Process Sheet

Customer	: CC-DAR01 Dart Aerospace Ltd.	Drawing Name	: REWORK
Job Number	: 33464		
Estimate Number	: 10804		
P.O. Number	: <i>N/A</i>	Part Number	: D25763
This Issue	: 11/07/2007 S.O. No. : <i>N/A</i>	Drawing Number	: D2576-3
Prsht Rev.	: <i>NC</i>	Project Number	: <i>N/A</i>
First Issue	: <i>N/A</i> Type : MACHINED PARTS	Drawing Revision	: <i>N/A</i>
Previous Run	: 00015	Material	: <i>N/A</i>
Written By	: <i>[Signature]</i>	Due Date	: 27/07/2007
Checked & Approved By	: <i>[Signature]</i>	Qty:	100 Um: Each
Comment	:

D2576-3 RE-WORK

From: Marc Bellavance [mbellavance@dartaero.com]
Sent: July 11, 2007 8:36 AM
To: 'L Lacelle'
Subject: D2576-3 Step Re-work
Attachments: D2576-3ReWork.pdf

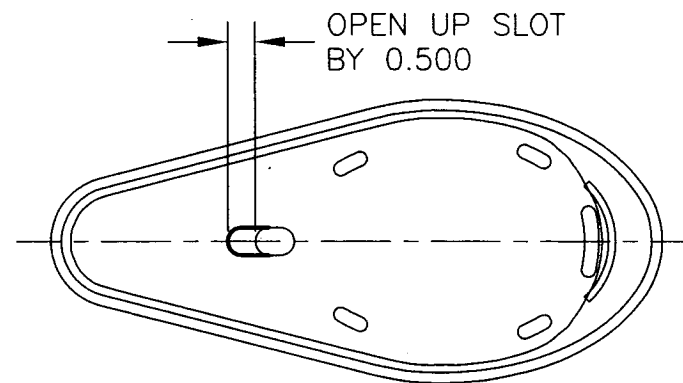
OPEN UP 0.50" WIDE SLOTS PER ATTACHED

Here are the instructions for the D2576-3 Step re-work:
Open up 0.50" wide slot as per attached sketch.
